# UNITED STATES PATENT AND TRADEMARK OFFICE

APPLICATION NO.	FILING DATE	FIRST NAMED INVENTOR	ATTORNEY DOCKET NO.	CONFIRMATION NO.
10/614,277	07/08/2003	Haruyoshi Ono	030824	7735

# Office Action Summary

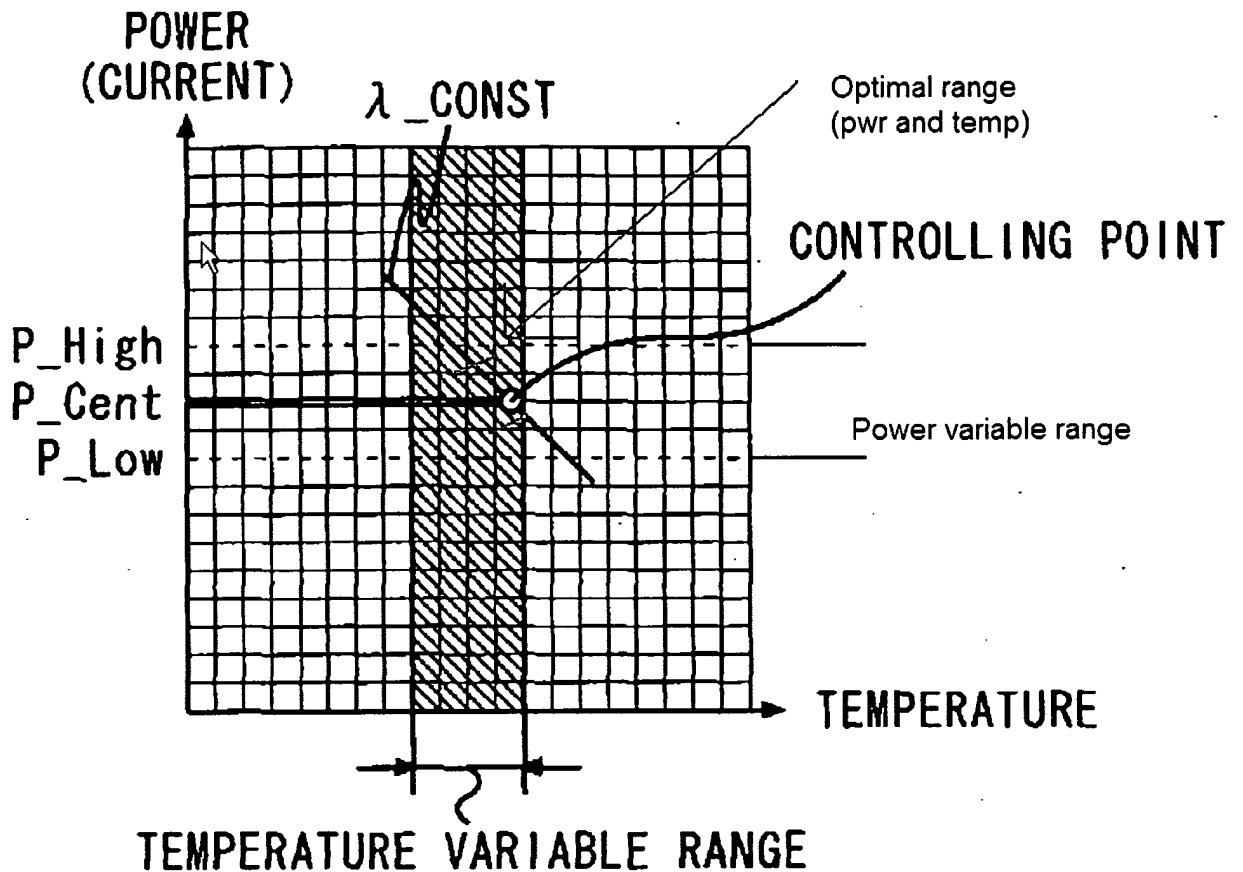
With respect to claims 9 and 19, the prior art discloses a setting value generating device that generates such a setting value that causes laser light emitted from a laser module to have a predetermined wavelength ( $\lambda$  target, spec. pg.4 line 17) and satisfies predetermined temperature conditions and predetermined power intensity conditions (fig.3a, defined temp / power ranges), the setting value generating device

comprising: an optimum power intensity calculating unit (fig.1 #120) that calculates an optimum power intensity setting range (fig.3a) that maintains the predetermined wavelength falls within a predetermined power intensity variable range (range can be considered equal to the intensity setting range, fig.3a) a predetermined power intensity variable range (maintained via APC feedback); an optimum temperature calculating unit (fig.1 #120) that calculates an optimum temperature setting range (fig.3a, pgs.4-5 lines 37-9) that maintains the predetermined wavelength and falls within a predetermined temperature variable range; and a setting value generating unit (fig.1 #120) that generates the setting value based on the optimum power intensity setting range (optimum is  $P_{cent}$ ) calculated by the optimum power intensity calculating unit and the optimum temperature setting range calculated by the optimum temperature calculating unit (setting values generated based on temp/wavelength/power, pg.6 lines 17-21), wherein the laser module can be operated with the setting value that is located within the predetermined temperature setting range and the predetermined power intensity setting range even when the laser module cannot operate within the predetermined temperature variable range ( ) at a center value of the predetermined power intensity variable range while the laser light is kept at the predetermined wavelength (As described at pg.2 lines 3-11 of the disclosure, the AAPA describes that the power value is controlled via an Automatic power control (APC), this control device is used to correct for minor deviations from a set value ( $P_{cent}$ ), therefor, the module can have a value which is not the center value of the predetermined power intensity variable range, and the APC will adjust the driving current to return it to the  $P_{cent}$  value).

As the prior art shows (fig.3a), the laser module can be operated at a point which is not at  $P_{Cent}$  while maintaining the chosen constant wavelength. When this happens, the APC takes over to return the system to the optimal value. When the system is not at the optimal value (before APC adjustment) the output wavelength can be unchanged (along  $\lambda\_const$  trend line) while inside both of the temperature and power predetermined variable ranges thereby reading on the claim limitations.
